EL PASO  **COUNTY**
COLORADO

RE: Project File #: SP-19-005
Project Name: Grandwood Ranch
Parcel No.: 61190-00-003

EXECUTIVE SUMMARY

Deviation Exhibit 3
Centerline
Roadway Grades
 Grandwood Ranch (LSC# 185020)

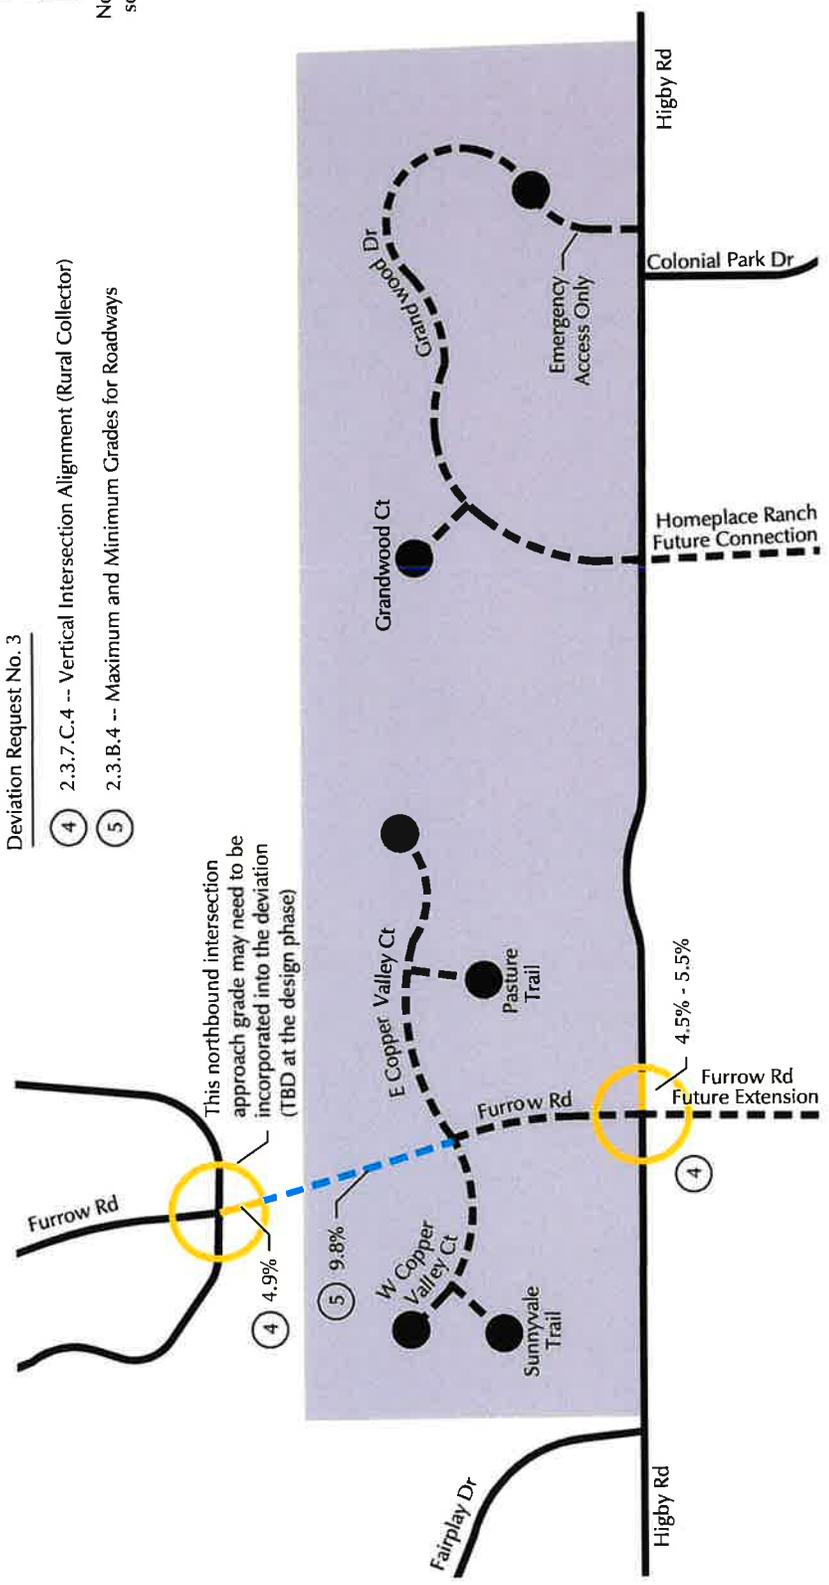
Deviation No. 3 (4-15-2020): A deviation from the standards of or in Sections **2.3.4.B and 2.3.7.C.4** of the Engineering Criteria Manual (ECM) is requested. The request is for intersection approach grades and "mid-block" centerline roadway grades exceeding the maximum allowable in the ECM. The details are described below. See attached Deviation No. 3 Exhibit by LSC and the attached plan and profile exhibit prepared by Matrix Design Group.

Figure B
Drainage Easement Should Be Extended

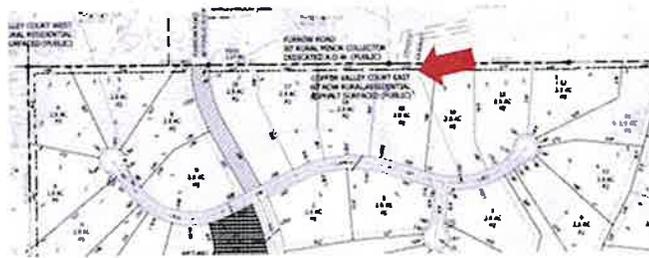
Mills Timber Subdivision has concerns related to the development of lot F2-15 as shown on the Grandwood Ranch Subdivision Preliminary Plan Drawings 5/08/19 (current version on EDARP website).

Photo 6 - Overview of wetland and pond on Drainage 1 in the southwestern part of the project area. View is to the southwest

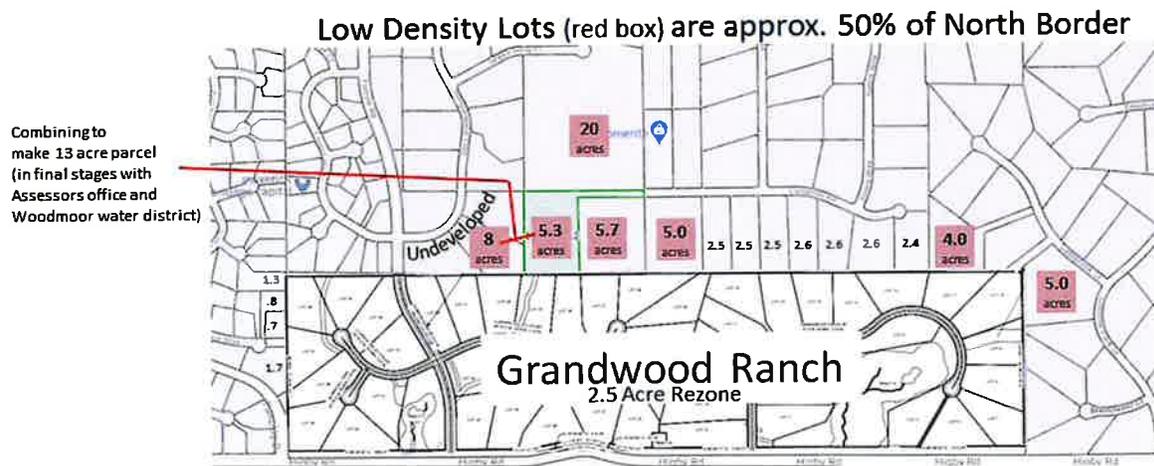
Lot F2-15 from Mills Timber Fence line Fed by flow from Pond. Flow feeds Wetland below.

Lower Wetland Designation / Preble Habitat (Wetlands Report 1/10/19)

Deviation Exhibit 2
Length of Cul-de-Sac
 Grandwood Ranch (LSC# 185020)

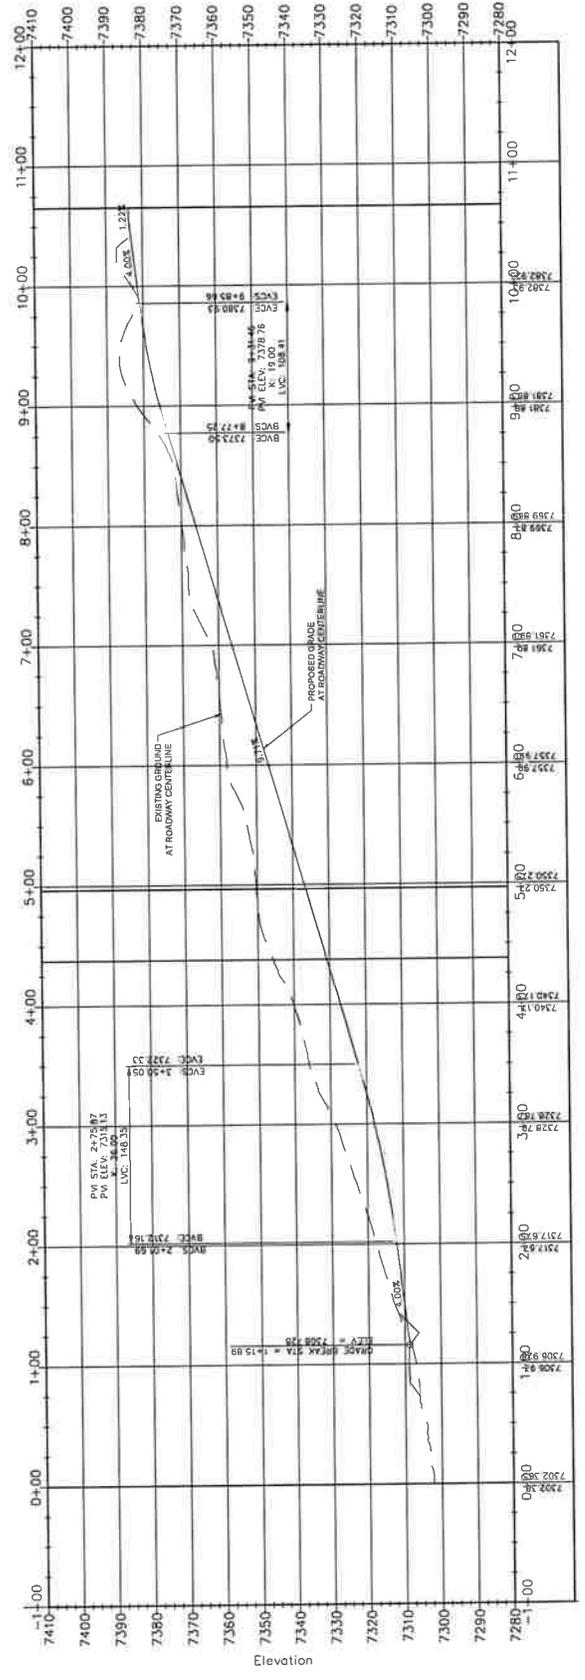
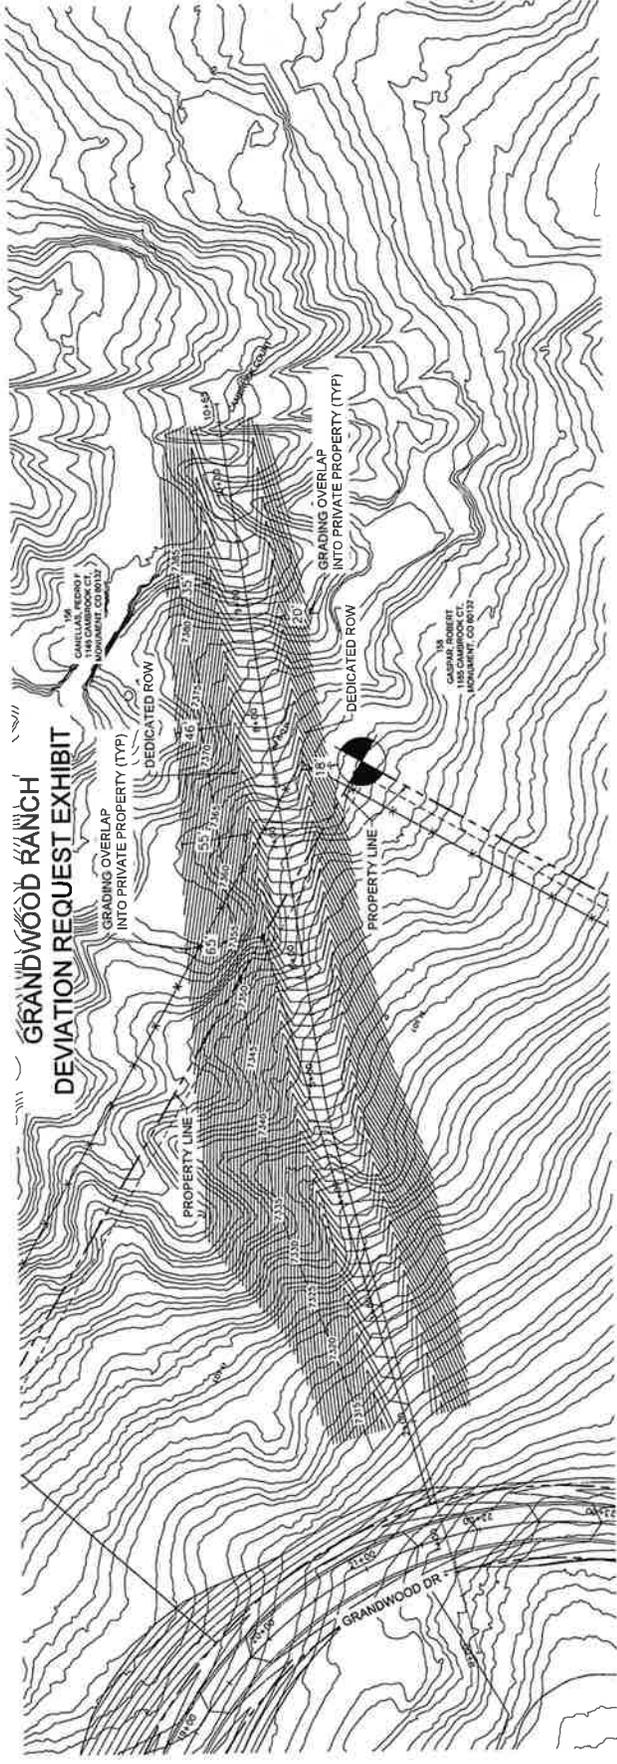
- The cul-de-sac termination on the east access (located 2,542 feet from Higby Road) would exceed the ECM standard of 1,600 feet by 942 feet.
- The proposed cul-de-sac is shown in the attached exhibit Figure 2 (site plan).
- An emergency-use only connection is proposed from the end of the cul-de-sac to Higby Road, as shown in the attached deviation exhibit.
- Twenty-one 2.5-acre lots would access this proposed cul-de-sac roadway. Five of these lots would also have frontage along Higby Road, although the homesite driveway accesses would be taken from the proposed internal road.
- Please refer to the attached letter from the fire district.
